# UNITED STATES PATENT AND TRADEMARK OFFICE

APPLICATION NO.	FILING DATE	FIRST NAMED INVENTOR	ATTORNEY DOCKET NO.	CONFIRMATION NO.
10/730,834	12/08/2003	Nick Kuo	JCLA11759	5204
27765	7590	03/27/2006	EXAMINER	
NORTH AMERICA INTELLECTUAL PROPERTY CORPORATION			ANDUJAR, LEONARDO	
P.O. BOX 506			ART UNIT	PAPER NUMBER
MERRIFIELD, VA 22116			2826

## Office Action Summary

## **DETAILED ACTION**

FIG. 2I

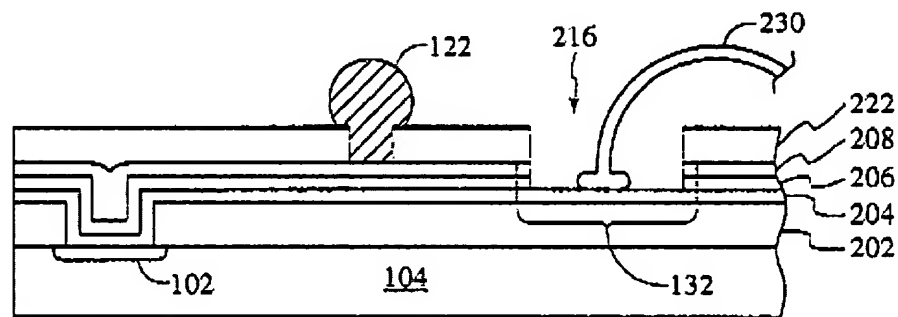
5. Regarding claim 27, Lam (e.g. fig. 2A-2I) shows a semiconductor substrate 104; a metallization 102 structure over the semiconductor substrate; a passivation layer 202 exposes a top surface of the metallization structure; a patterned circuit layer 204-208 connected to the top surface, wherein the patterned circuit layer comprises a first portion 214 having a bump 122 formed thereover and a second portion 216 used to be wirebonded thereto (col. 1/23-33 & co. 2/lls. 30-51).

7. Regarding claim 32, Lam teaches a polymer 222 on the patterned circuit layer, an opening in the polymer layer exposing the first portion (col. 2/lls. 61-65 & col. 3/lls. 23-39).

8. Regarding claim 34, Lam shows that the patterned circuit layer comprises a metal trace connecting the first and second portions.

9. Regarding claims 40 and 41, Lam shows solder bump 122 over the first portion (col. 2/lls. 39-41).

10. Regarding claim 42, Lam shows a copper layer between the bump and the first portion (col. 3/lls. 1-10).

11. Regarding claim 44, Lam shows a wirebonded wire 230 bonded over the second portion.

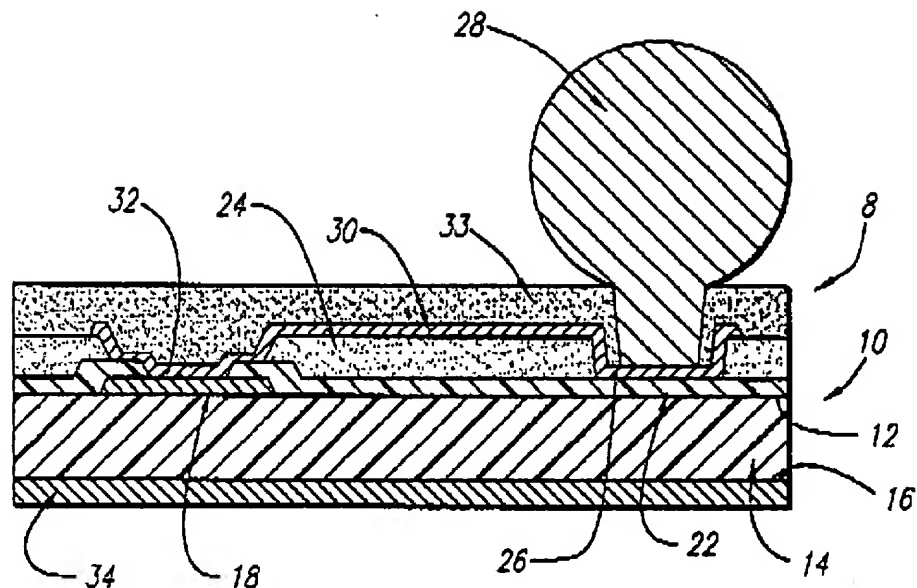
14. Regarding claim 1, Elenius (e.g. figs. 1 & 2) shows a substrate 14, a metallization structure 18 over the semiconductor substrate; a passivation layer 22 over the metallization structure 18, wherein an opening in the passivation layer exposes a top surface of the metallization structure and a patterned circuit 30 connected to the top surface, wherein the patterned circuit layer comprises a first portion having a bump 28 formed thereover and a second portion (col. 1/lls. 22-45 & col. 6/lls. 1-37).

**FIG.3**

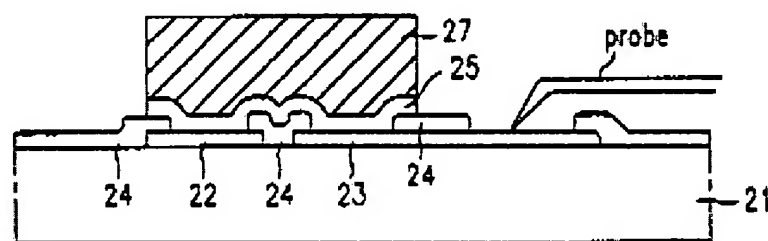
Elenius does not teach a testing pad or second portion used to be tested thereto. Nevertheless, Kim (e.g. fig. 3) shows a testing pad 23 electrically connected to a bump pad 22. This type of embodiment prevent decreases in testing reliability caused by damages on the surface of the bump and polluting material thereby enhancing its yield with respect to bonding (col. 2/lls. 10-30).

It would have been obvious to one of ordinary skill in the art at the time the invention was made to include a second portion used to be tested thereto or include a test pad electrically in order to prevent decreases in testing reliability caused by

damages on the surface of the bump and polluting material during the testing process, thereby enhancing its yield with respect to bonding as taught by Kim.
